670 PLACERVILLE DR PLACERVILLE, CALIFORNIA

SITE SURVEY & ADA EVALUATION

DECEMBER 28, 2012

ADA COMPLIANCE
CONSULTANTS, INC
.....
Our System is the Solution

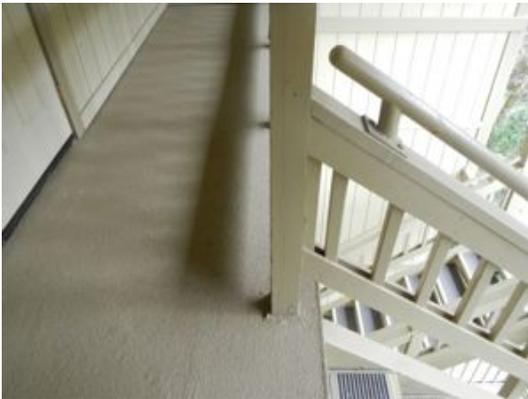
8.13	Other Picket width	Yes <input type="checkbox"/> No <input checked="" type="checkbox"/> N/A <input type="checkbox"/>	If you have identified any other related barriers that were not covered by this survey form, check the "No" field and provide that information below.	5 1/2"

SCOPE: Install directional signage at all entrances to this non-compliant stair set directing the disabled to the nearest accessible exit/entrance/elevator. ADACC recommends reconstruction of this main stair set when financially feasible to provide compliant handrails with extensions, door landing clear space and 48" clear rescue width between all floors.

STAIRS

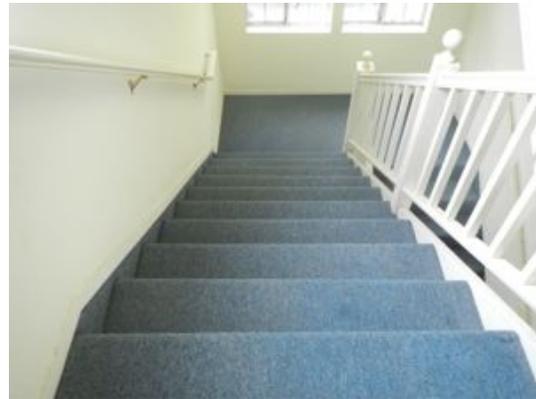
8.13	Other Picket gap / signage	Yes <input type="checkbox"/> No <input checked="" type="checkbox"/> N/A <input type="checkbox"/>	If you have identified any other related barriers that were not covered by this survey form, check the "No" field and provide that information below.	5 ½" gap for all pickets / lacks stair signage

SCOPE: Install directional signs to redirect the disabled to the nearest accessible entrance / exit. ADACC recommends reconstruction when financially feasible to provide fully compliant stair set. Install 2" contrasting color strips on bottom tread and top approach within 1" of front nosing. Install new 1 ½" diameter handrails with extensions as shown above.

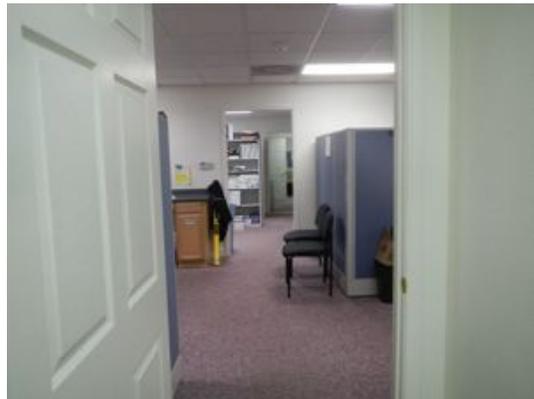
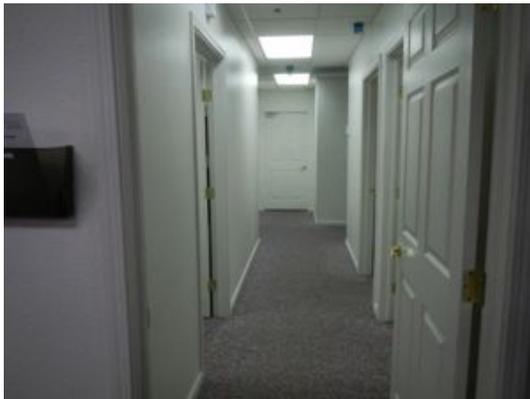
12.13A	Alarms	Yes <input type="checkbox"/> No <input checked="" type="checkbox"/> N/A <input type="checkbox"/>	If emergency warning systems are provided, do they include both audible alarms and visual alarms complying with Survey Form - Alarms? 702.1 /// 907.9.1, 907.9.2, 1114B.2.2	Lacking

SCOPE: See Alarms form for alarm scoping. Remove interior hallway door on first floor leading from tenant lobby toward west end. Relocate cubical walls.
